Richen Industrial Co. Ltd.

We declare the following differences between old and new PCBA for FCC ID: RMZ-A3B.

A3 correlation table	
NEW	OLD

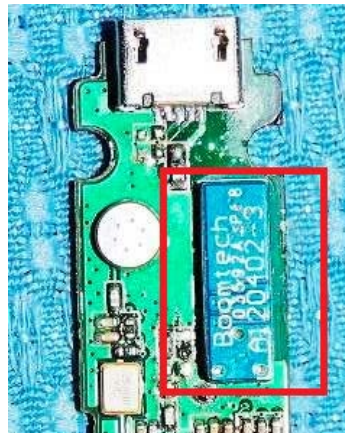
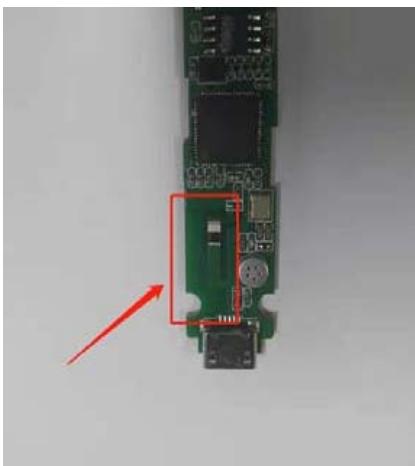
1	Antenna design
Part Name:WAN3216F245L08_v3.8 Manufacturer: wancheng	Part Name:RGFRA1204021A1T Manufacturer:huake

Note: the same type antenna with the same gain

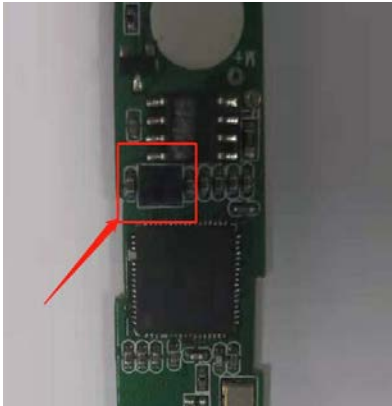
2	Inductance manufacturers	
	Cuntian 4.7uh	TDK 4.7uh

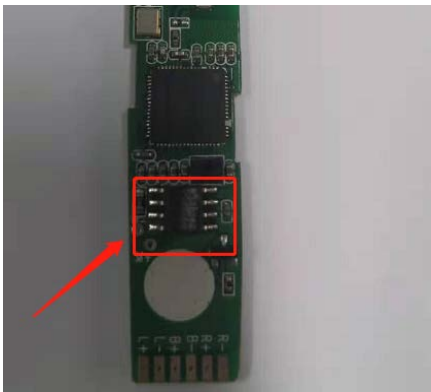
3	FLASH manufacturers	
	geer	yuesheng
